WATERFORD VENTURE

WATERFORD, CONNECTICUT

**EASTERN CONNECTICUT
ENVIRONMENTAL
REVIEW TEAM
REPORT**

REVIEW DATE: OCTOBER 13, 1988

ILLUSTRATIVE SITE PLAN

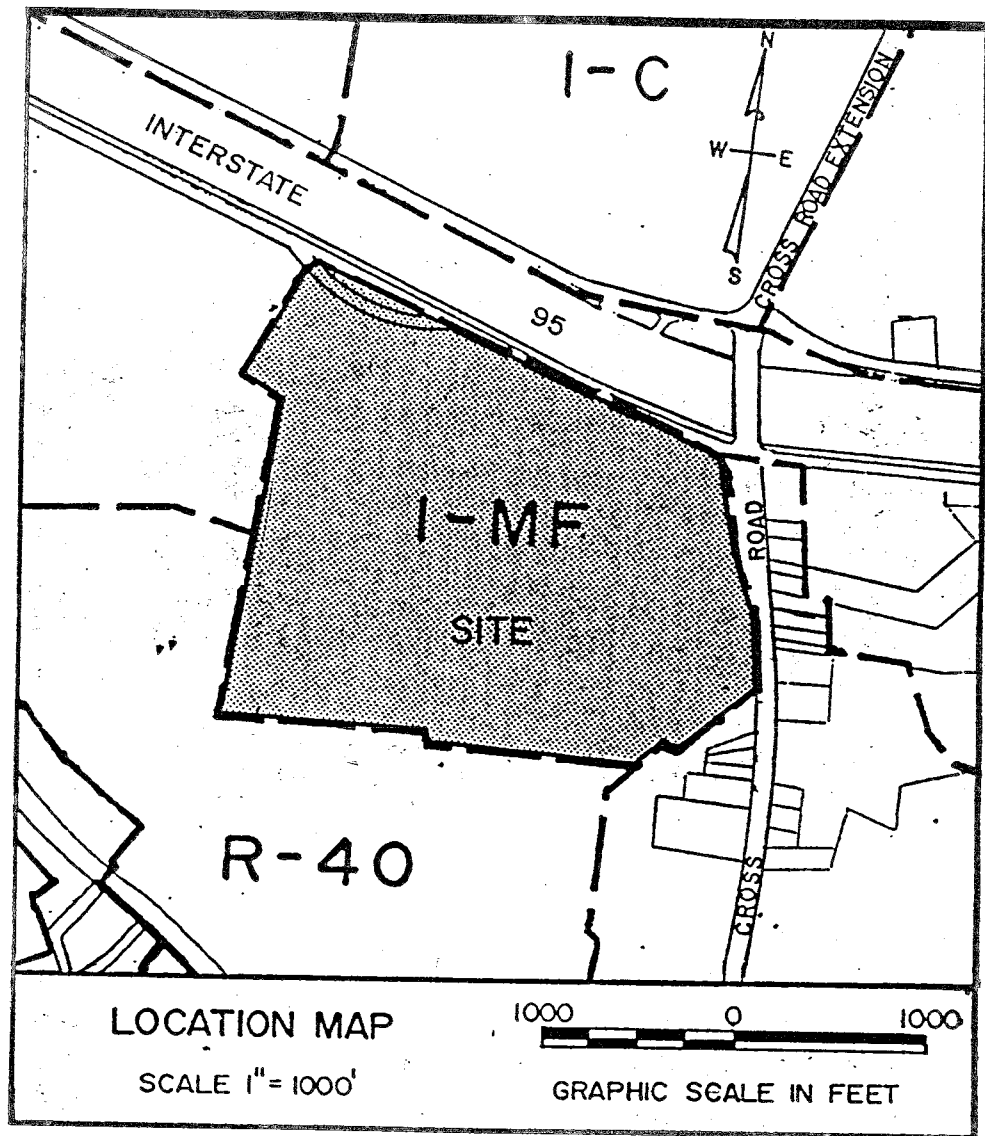
As indicated on the site plan all areas except wetlands will be developed. This will eliminate the present diversity of wildlife habitat, which

The site plan shows about 100,000 square feet of the site occupied by office building, half of which are presumed to be two stories, indicating 150,000 square feet of building area used for offices. Again, using ITE trip generation rates, the offices would produce 14.3 trips per 1,000 gross square feet of building area, or 2,145 vehicle trips per day. The total estimated traffic generated by the proposed development would be 6,378 vehicles per day.

The north/south collector road through the approximate center of the site is proposed for eventual construction through to Route 1 to the south. This is highly desirable, but the timing is quite indefinite. The same is true for the relocation of the I-95 exit/entrance. Consequently, a heavy burden is likely to be placed on the proposed east/west road connecting with Cross Road. It should be constructed to the same standard as the north/south collector road.

The driveway to Parkway South proposed near the northeastern corner of the site should be limited for use by the office complex in that area. The residential traffic from the terraced housing area should be directed toward both of the interior collector roads. This implies construction of a direct link between the terraced housing area and the east/west collector road. Contour information suggests that this might best be accomplished opposite the western driveway serving the housing in the southeastern quadrant of the site. The purpose of this arrangement is to direct as much traffic as possible toward intersections which are more likely to be controlled by traffic signals in the future, that is, on Parkway South, opposite the proposed new ramps, and on Cross Road, where it will intersect with the proposed east/west roadway into the site.

Each of the 4 residential villages is to be served by a looping driveway which serves two-way traffic and widens in numerous locations to allow perpendicular parking along one or both sides. Thus, the roadway itself becomes the maneuvering area for the roadside parking spaces. Because of the high number of vehicles these villages will generate, better separation of parking and major accessways appears desirable.

The site plan shows that recreation facilities will be provided in the northwestern corner of the site. If these are to be for use by residents of the villages, they should be more easily accessible. A central location, connected to the residential areas by sidewalks or walkways, would be appropriate. The users of neighborhood recreation facilities should not have to travel by motor vehicle to get to them.

AREAS OF POTENTIAL

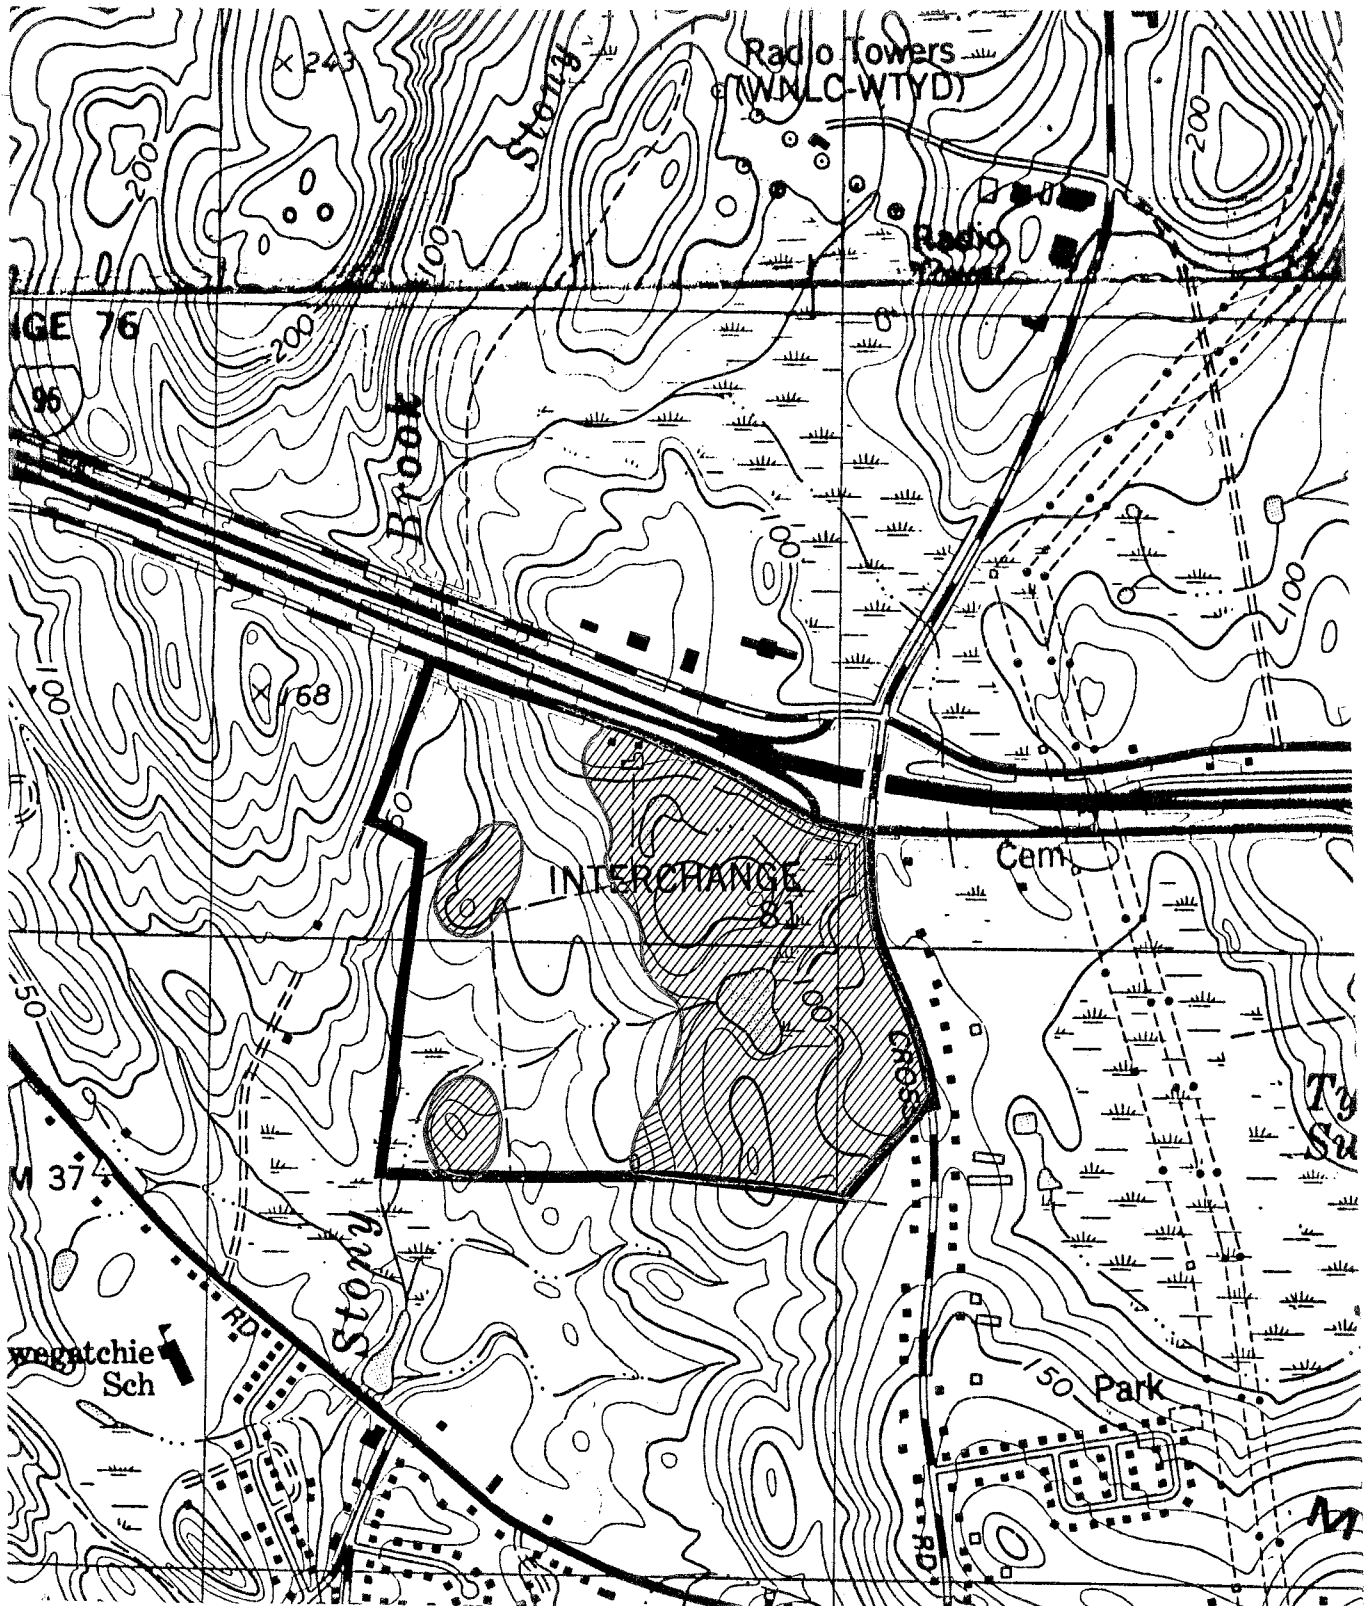
It is recommended that an archaeological reconnaissance survey be conducted in sections of the project area that may have a high sensitivity to cultural resources. All archaeological studies should be undertaken in accordance with the Connecticut Historical Commission's Environmental Review Primer for Connecticut's Archaeological Resources.

In summary, the project area has a moderate-to-high sensitivity for prehistoric archaeological sites. It is recommended that all feasible efforts be undertaken to identify and ensure the preservation and conservation of the cultural resources in the project area.
